Design Review Committee Meeting

700 Doug Davis Drive
Hapeville, GA 30354

November 18, 2020 6:00 PM

**DEPARTMENT OF PLANNING AND ZONING
PLANNER'S REPORT**

2
A3
NEW FRONT ELEVATION
1/4" = 1'-0"

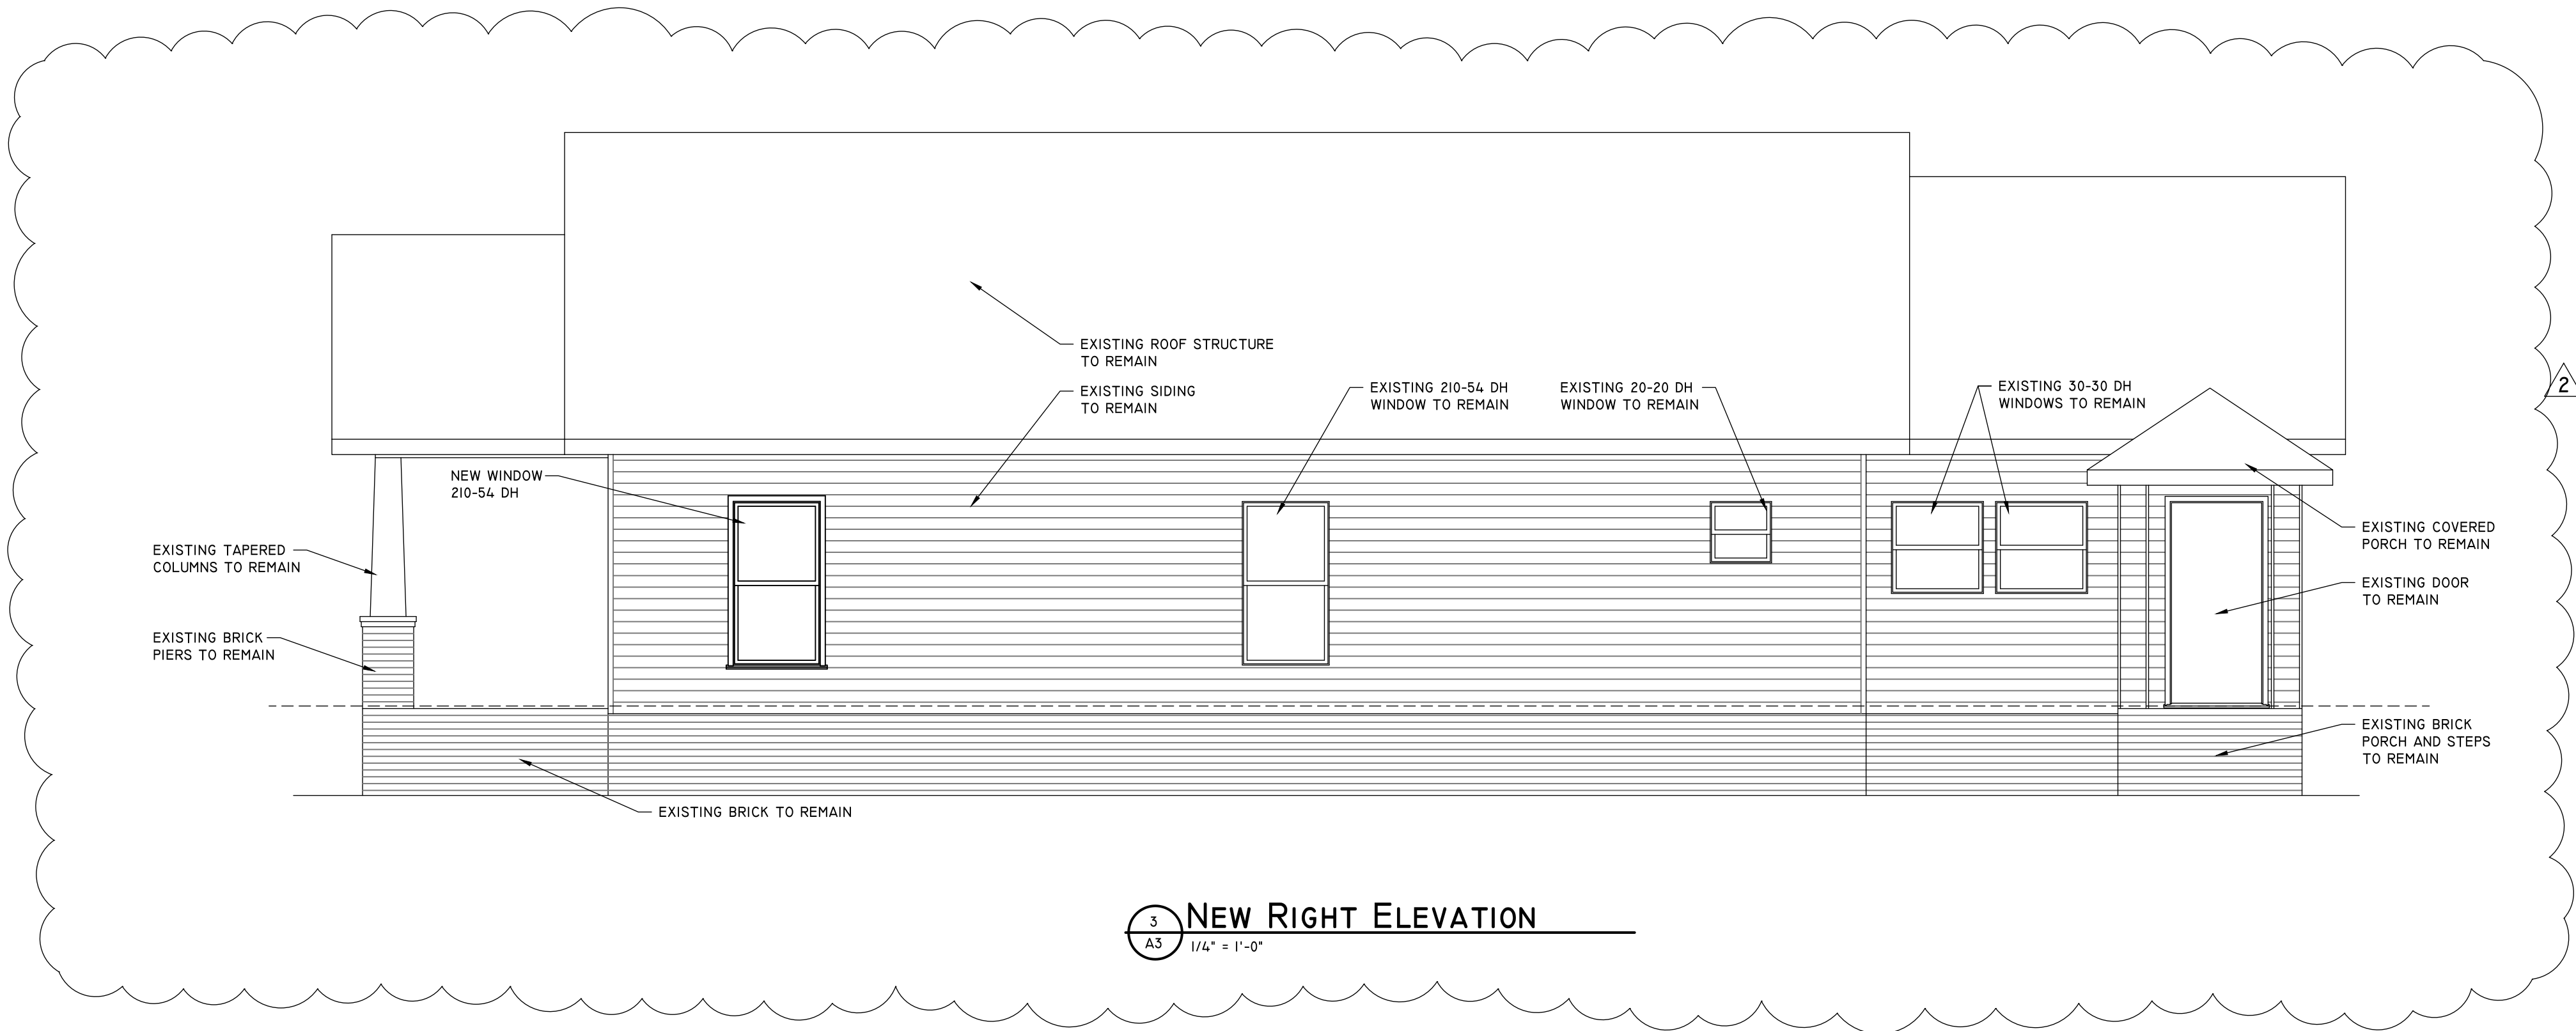
Window trim shall not be flush with the exterior facade and shall provide a minimum relief of one-quarter inch or greater.

BUILDING ELEVATION - NORTH

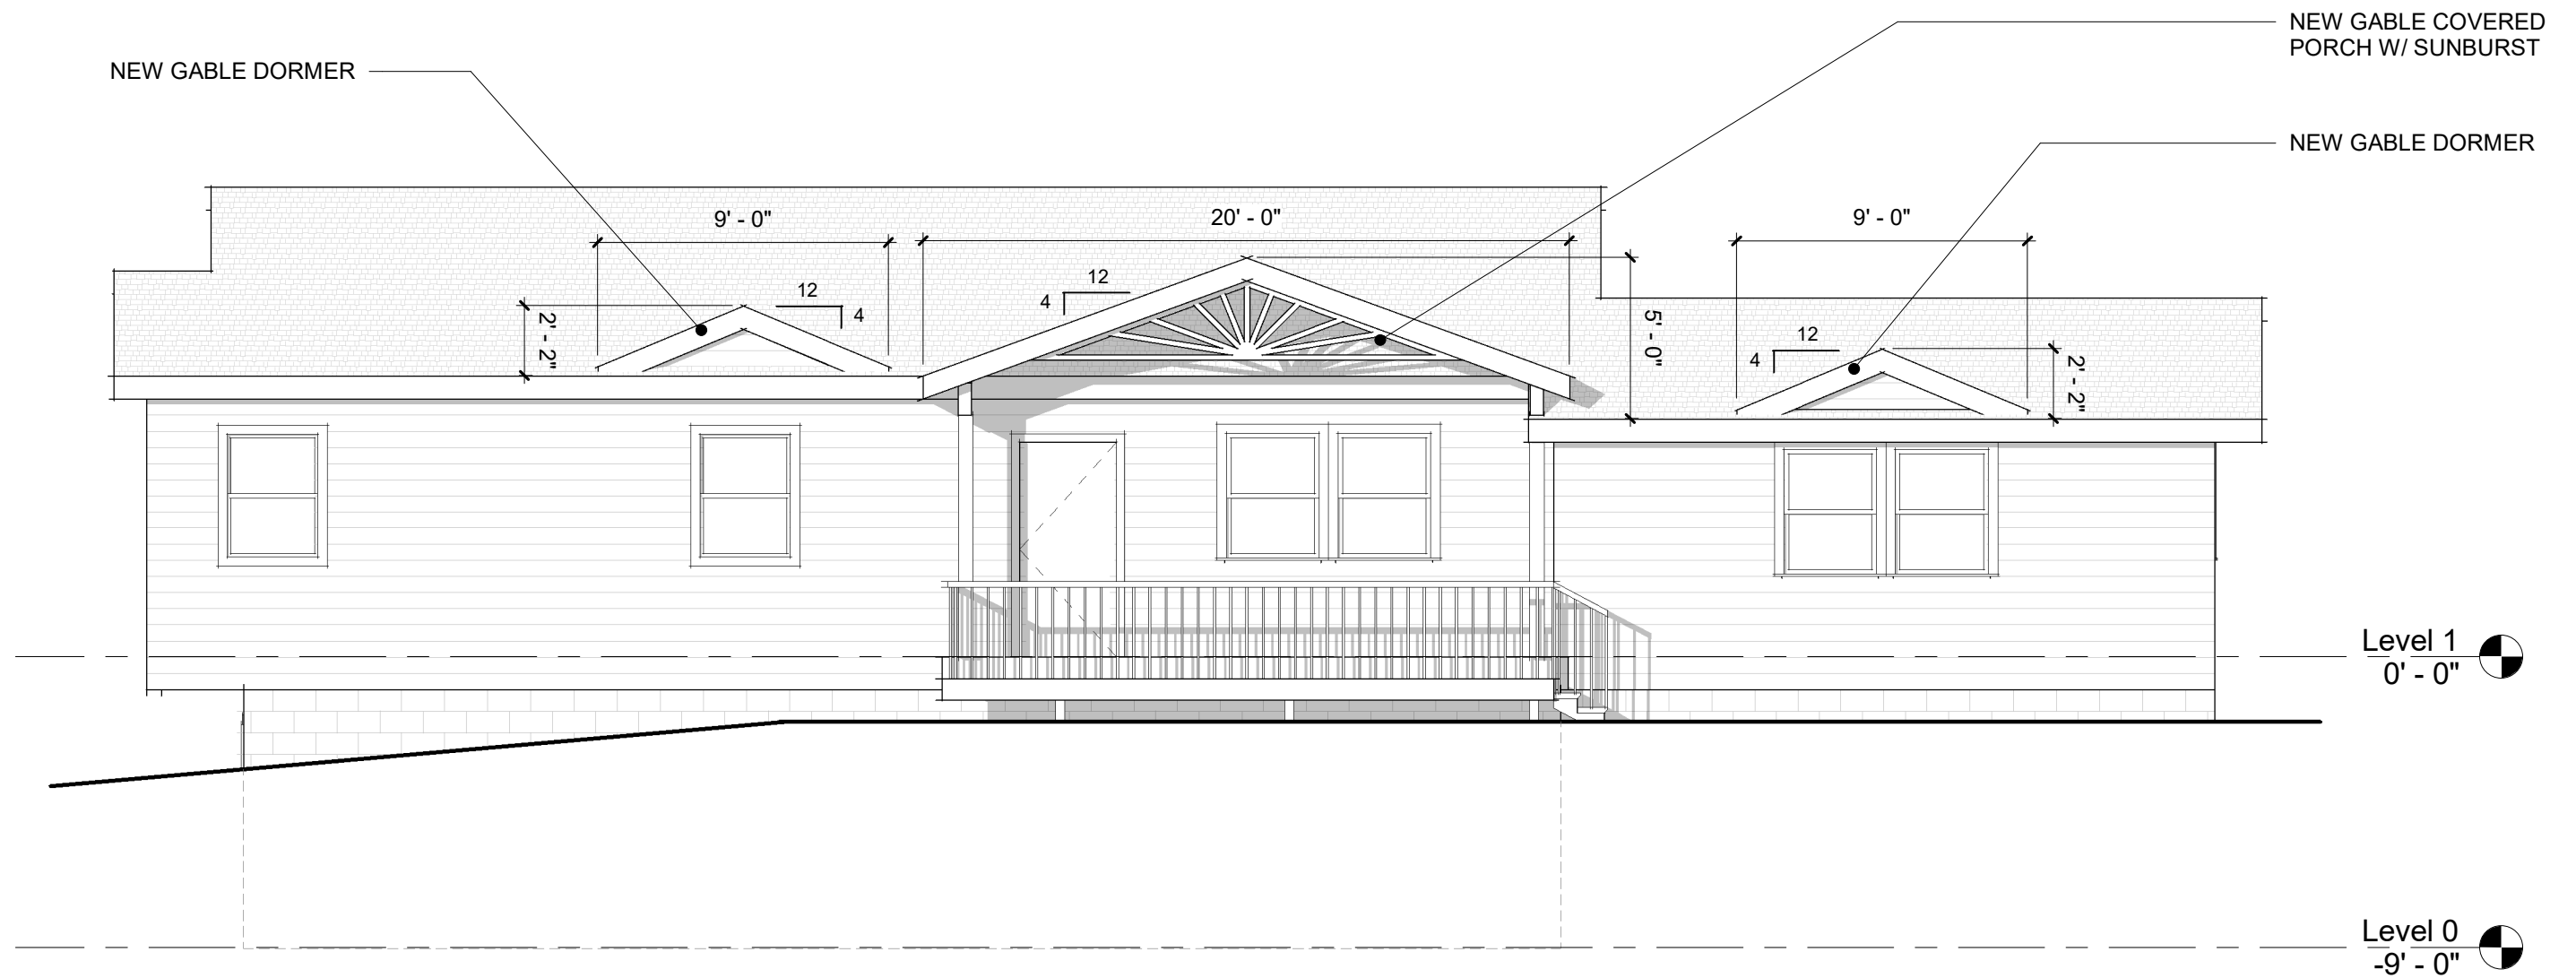
STAFF COMMENT: *Windows are replacement windows, but appear to be different dimensions on far left.. Trim and sills not provided.*

1. A front deck was installed in lieu of a porch and does not meet the porch specifications.
2. Window trim and sills not provided. Missing window detail. Window at far left seems to be different dimension than original (from photo)
3. Sunburst design not allowed on the gable.
4. Roof shingle warranty not provided.
5. Gutter and downspout information not provided.

3376 NORTHSIDE DR FLOOR PLAN

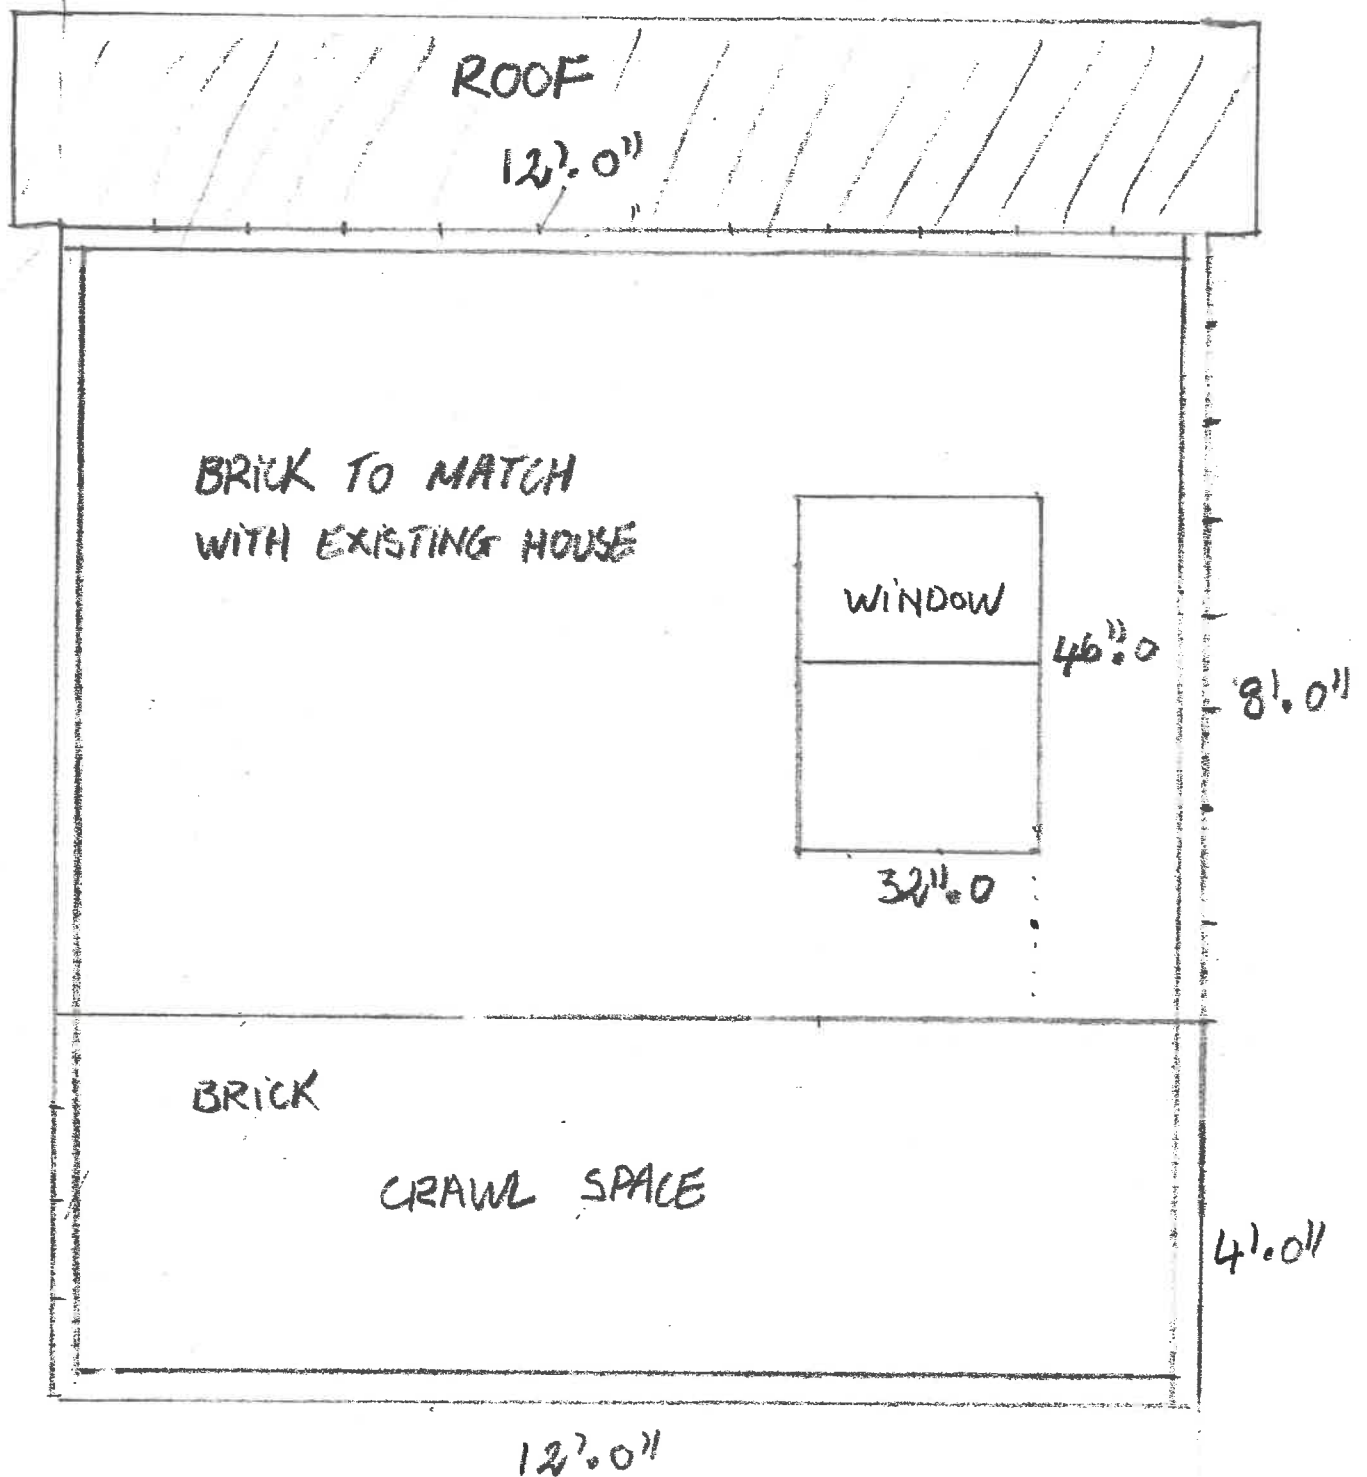
STAFF COMMENT: No window detail provided.
